To: The Preserve at San Juan, LLC
c/o J.P, Weber Group
2697 N. Vista Glen Road
Orange, CA 92867

October 23, 2014

Project No. 12-054
Permit No. PA130026

Subject: Response to County Review Comments dated September, 2014, regarding the proposed Onsite Waste Water Treatment System, "The Preserve at San Juan" County of Orange, California

Location of EI Test

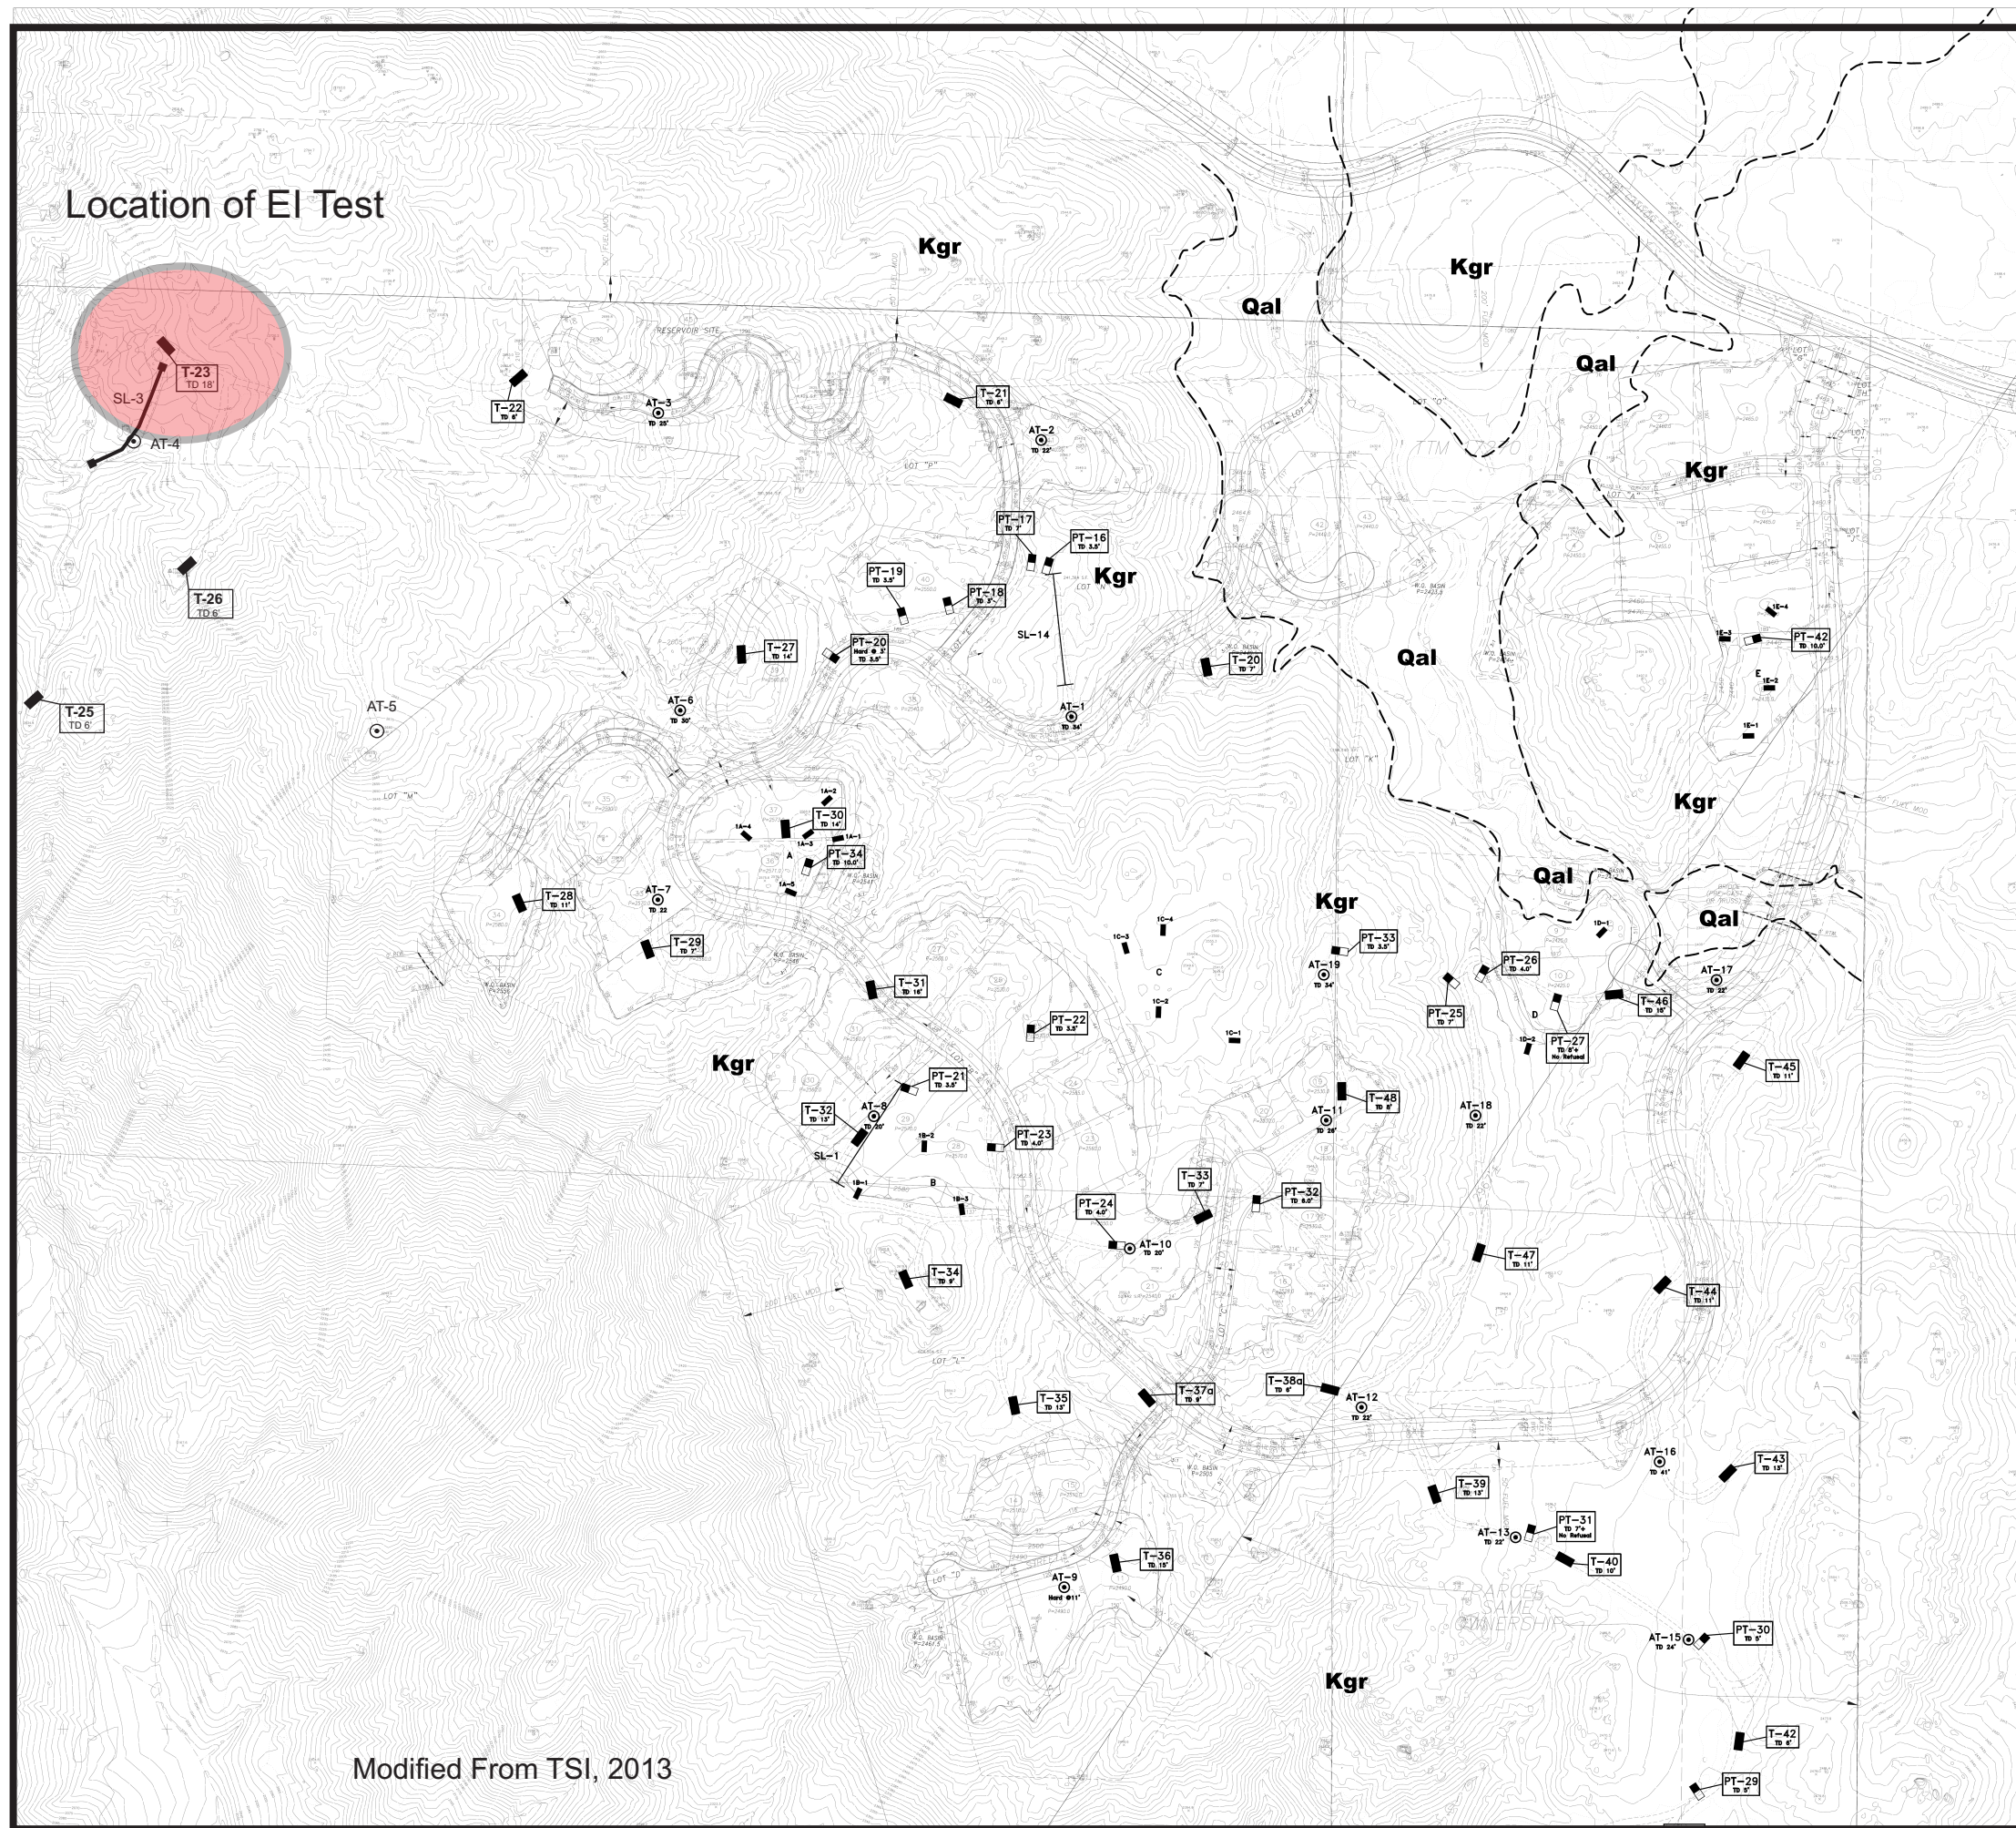
32) Provide site specific laboratory data to support statement from submitted report (Page 4) that site soils are very low to non-expansive. Include Plot Plan to indicate the location of samples tested.

Response to Comment: Geology reports are attached as Appendix F to the EIR and contain descriptions and laboratory data regarding the material present at the site. The proposed OWTS will disperse the reclaimed water onto the slopes that are adjacent to the individual lots. In all cases these will be fill slopes. Fill soils will be constructed with soils that are anticipated to consist of sand and silty sand. (decomposed granite), that are expected to be permeable and have favorable high shear strengths. Three expansion index tests were conducted at the site for EIR purposes. Two of the tests yielded a 0 expansion index (EI), and one other had a 2 EI (see appended laboratory test results). the attached Plates 1, 2A and 2B show the location of the trenches where these samples were collected. Two trenches were in the northern tract, and one trench was in the southern tract. As normally required, additional testing will be conducted during later phases of the project.
